Access Compliance Report

Public Rights-of-Way

(Curb Ramps)

Intersection ID: 10033070	Main Street: NORTH_COMMUNITY_HOUSE_RD	Cross Street: N/A	Location: NW
ADA ID: 97A9B0717C4F	Ramp Type: Directional	Initial Pass/Fail: Fail	Overall Compliance: No
		Severity Score: 1.25

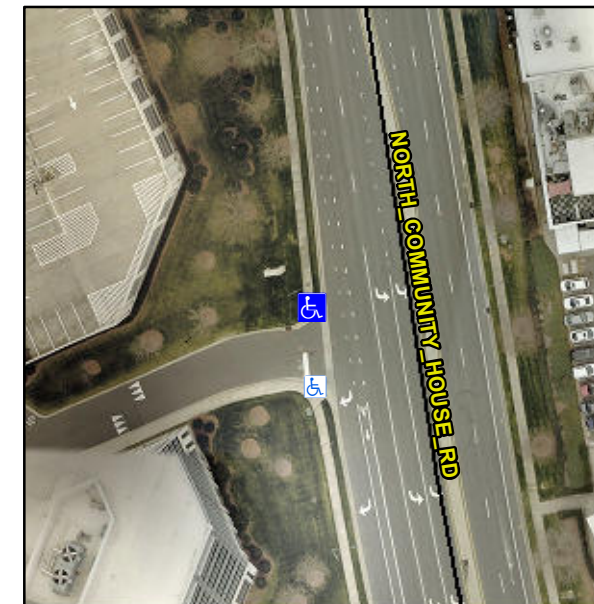
R304.5.3

Compliance	Description	Data	Compliance	Description	Data
N/A	Ramp Length (in)	73.0	N/A	Grade Break?	N/A
Yes	Ramp Width (in)	57.0	N/A	Grade Break Slope (%)	0.0
Yes	Ramp Slope (%)	2.0	N/A	Grade Break XSlope (%)	0.0
No	Ramp XSlope (%)	5.0			
N/A	Flare Type LT	N/A	N/A	Flare Type RT	N/A
N/A	Flare Slope LT (%)	N/A	N/A	Flare Slope RT (%)	0.0
N/A	Flare Traversable LT?	N/A	N/A	Flare Traversable RT?	N/A
N/A	Landing Length (in)	0.0	N/A	DWS Provided?	N/A
N/A	Landing Width (in)	0.0	N/A	DWS Contrast?	N/A
N/A	Landing Slope (%)	0.0	N/A	DWS Length (in)	N/A
N/A	Landing X Slope (%)	0.0	N/A	DWS Full Width?	N/A
N/A	Landing Curb? (Y/N)	N/A	N/A	DWS Offset LT (in)	N/A
N/A	Shared Landing?	N/A	N/A	DWS Offset RT (in)	N/A
N/A	Gutter Ponding?	0.0	N/A	Gutter Slope (%)	N/A
N/A	Gutter Lip Ht (in)	0.0	N/A	Gutter X Slope (%)	N/A
N/A	Painted X Walk1?	No		Road Slope (%)	2.0
	X Walk 1 Direction	To SE		Road X Slope (%)	5.0
	X Walk 1 Width (in)	N/A		Clear Space?	N/A

Remove & Replace Entire Ramp.
